STATEMENT OF CASE

APPEAL SITE 12 Gloucester Gate, 12 & 13 Gloucester Gate Mews, NW1 4HG

Erection of a double height glazed link connecting 12 Gloucester Gate and 12 and 13 Gloucester Gate Mews and associated works.

COUNCIL REFERENCE: 2023/1742/P & 2023/2290/L

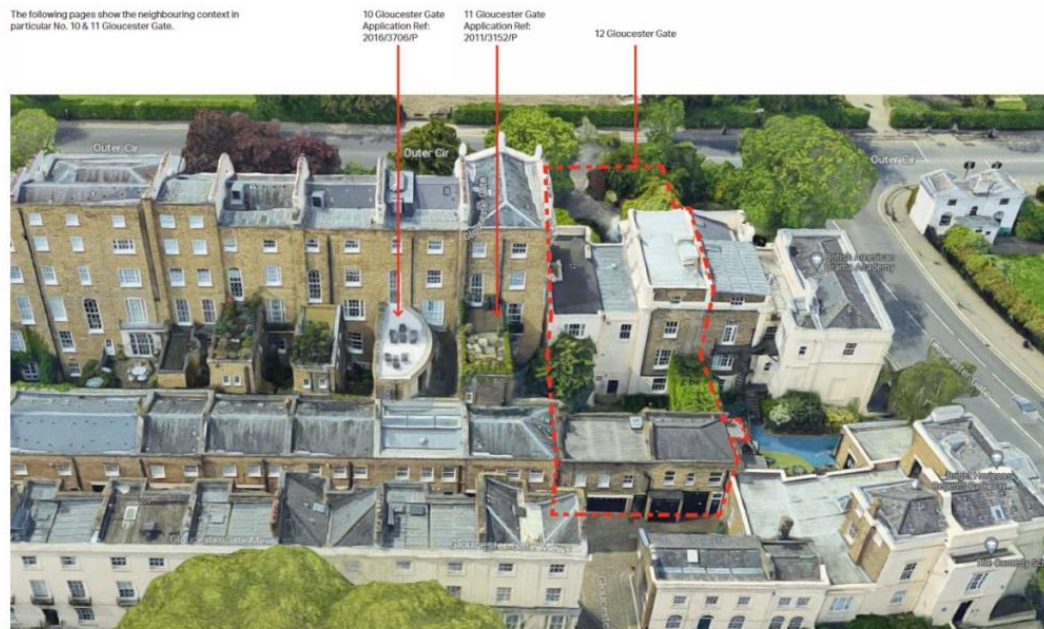
5.14. The proposed link extension would cause harm to the Grade I listed host building and its setting, the setting of its curtilage buildings, the setting of adjacent Grade I listed buildings, and to the character and appearance of the Regent’s Park Conservation Area.

5.15. In this instance, the harm is considered to be at the high end of less than substantial and in the absence of public benefit, no balance can be found. This scheme is considered, in the words of Planning Practice Guidance: Historic Environment, of “private benefit” and is considered to neither sustain
